# Access Compliance Report

## Public Rights-of-Way

### (Curb Ramps)

Intersection ID: 13679	Main Street: EUCLID_AV	Cross Street: LEXINGTON_AV	Location: S
ADA ID: CFBF115477A6	Ramp Type: Directional1	Initial Pass/Fail: Fail	Overall Compliance: No
			Severity Score: 13.75

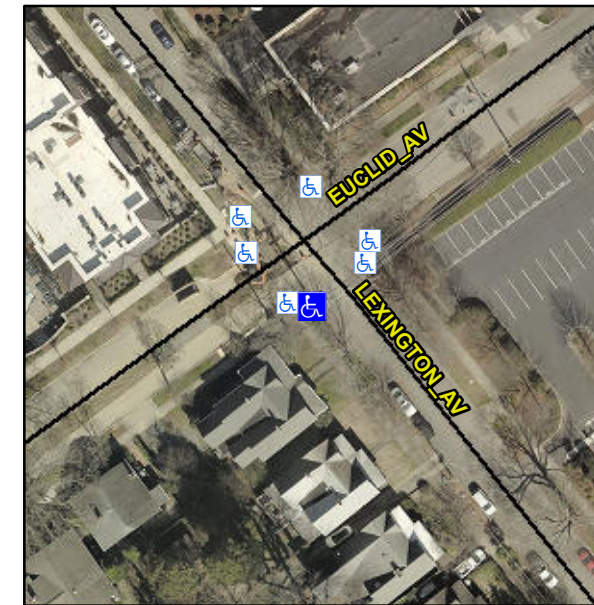
**R304.2.2, R304.5.3**

Compliance	Description	Data	Compliance	Description	Data
N/A	Ramp Length (in)	70.0	N/A	Grade Break?	N/A
Yes	Ramp Width (in)	58.0	N/A	Grade Break Slope (%)	0.0
No	Ramp Slope (%)	8.9	N/A	Grade Break XSlope (%)	0.0
No	Ramp XSlope (%)	4.1			
N/A	Flare Type LT	N/A	N/A	Flare Type RT	N/A
N/A	Flare Slope LT (%)	N/A	N/A	Flare Slope RT (%)	0.0
N/A	Flare Traversable LT?	N/A	N/A	Flare Traversable RT?	N/A
N/A	Landing Length (in)	0.0	N/A	DWS Provided?	N/A
N/A	Landing Width (in)	0.0	N/A	DWS Contrast?	N/A
N/A	Landing Slope (%)	0.0	N/A	DWS Length (in)	N/A
N/A	Landing X Slope (%)	0.0	N/A	DWS Full Width?	N/A
N/A	Landing Curb? (Y/N)	N/A	N/A	DWS Offset LT (in)	N/A
N/A	Shared Landing?	N/A	N/A	DWS Offset RT (in)	N/A
N/A	Gutter Ponding?	0.0	N/A	Gutter Slope (%)	N/A
N/A	Gutter Lip Ht (in)	0.0	N/A	Gutter X Slope (%)	N/A
N/A	Painted X Walk1?	No		Road Slope (%)	3.0
	X Walk 1 Direction	To NE		Road X Slope (%)	2.7
	X Walk 1 Width (in)	N/A		Clear Space?	N/A

**Remove & Replace Entire Ramp.**
